### EASA.A.642

<b>Type Design:</b>	<b>Bristell B23</b>
<b>Model</b>	<b>Initial Certification Date*</b>
Bristell B23	07 October 2020
Bristell B23-915	13 January 2022
Bristell B23-915 IFR	09 December 2024

Minor Design Change - Configuration Change no AEPS system

<p>Aircraft Design Certification GmbH Reichensteinstr.48 69151 Neckargemünd</p>		<p>Bristell - B23</p>	<p>Doc-Nr: ADxC-73-DC-008 Issue: A Date: 29.04.2021</p>
<p>Minor Design Change - Configuration Change no AEPS system</p>

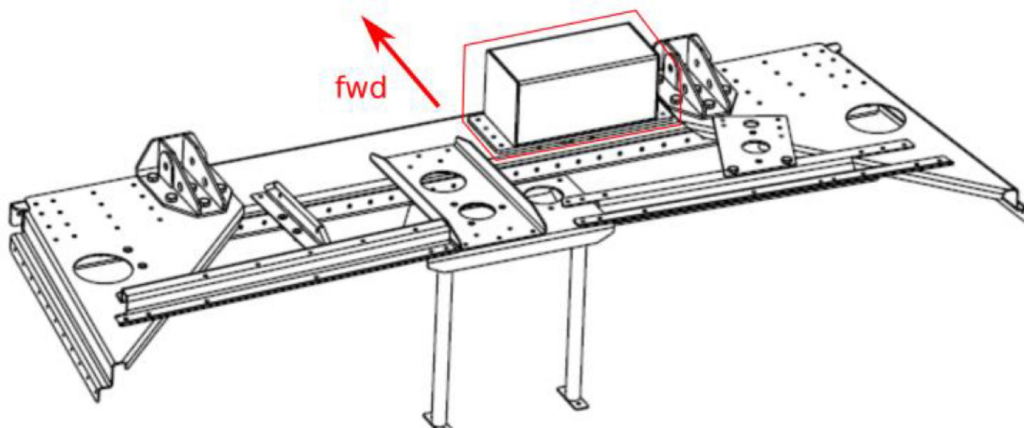
Change of configuration: installation of mass balance instead of the AEPS system as can be seen in the drawing below (marked area) next to the front RHS engine mount bracket and adjacent to the firewall.

The dummy mass consists of a welded steel casing filled with lead to a total mass of 12kg. It is riveted to the structure (front fuselage cross channel) by means of 4,0x12,7mm pop-rivets.

Removed parts (compared to basic configuration) is just one supporting bracket for the AEPS system:
